TECHNICAL BULLETIN

206-94-146

Revision A, 21 May 2014

SUBJECT: ANTI-TORQUE CONTROL SYSTEM HYDRAULIC BOOST, REMOVAL OF.

Figure 4 - (Sheet 1 of 3)

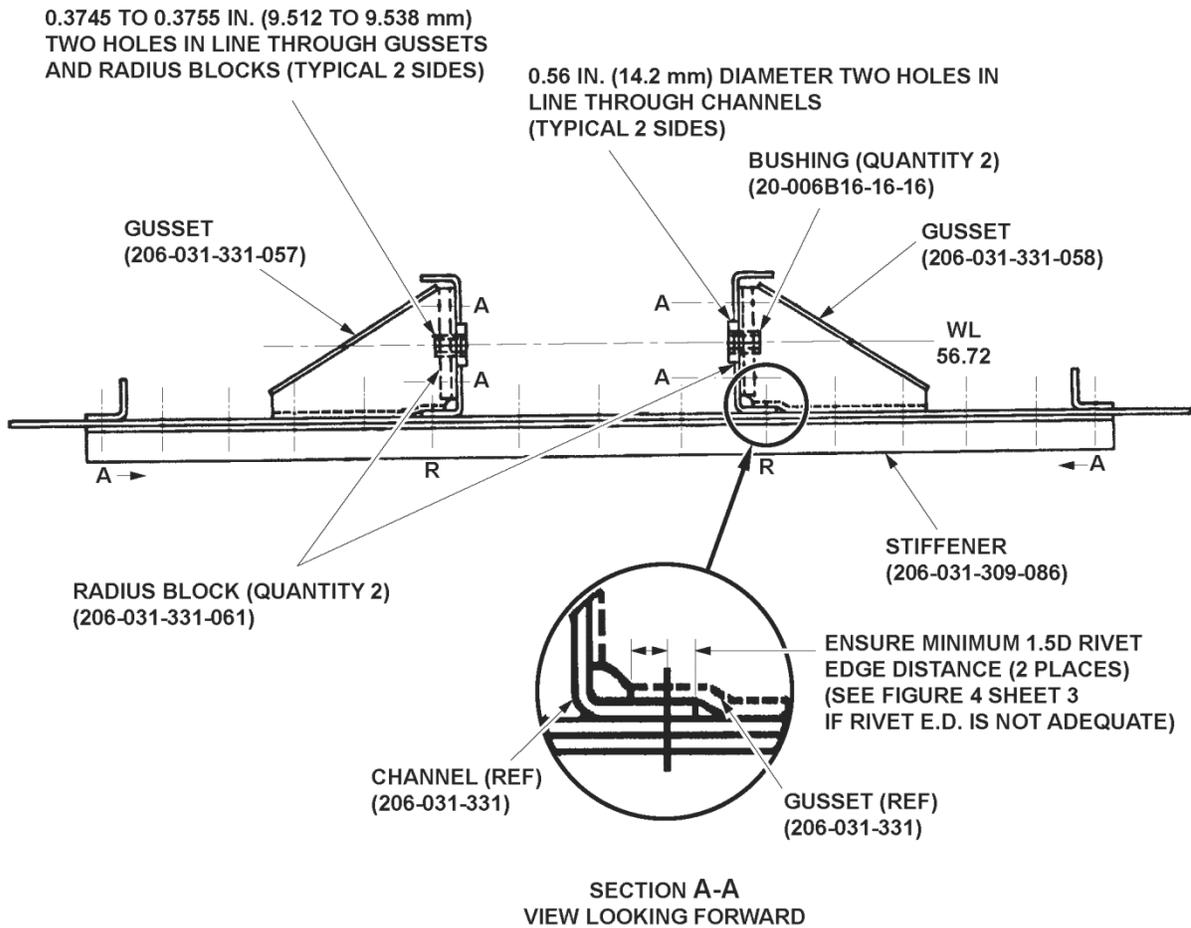
6. Locate the gussets 206-031-331-057 and -058, and the radius blocks 206-031-331-061 on channels 206-031-331-047 and -048 as shown in Figure 4. Drill with a No. 30 drill and cleco in place. Note; the rivets at the inboard end of the gussets must have at least 1.5D edge distance. If this cannot be achieved, the gussets must be modified per Figure 4, Sheet 3.

11. Enlarge the No. 40 pilot holes in the radius blocks and the gussets and line ream to 0.3745 to 0.3755" (9.512 to 9.538 mm) diameter. Deburr the holes and prime the bare metal with primer (C-204). Install the bushings as shown in Figure 4.
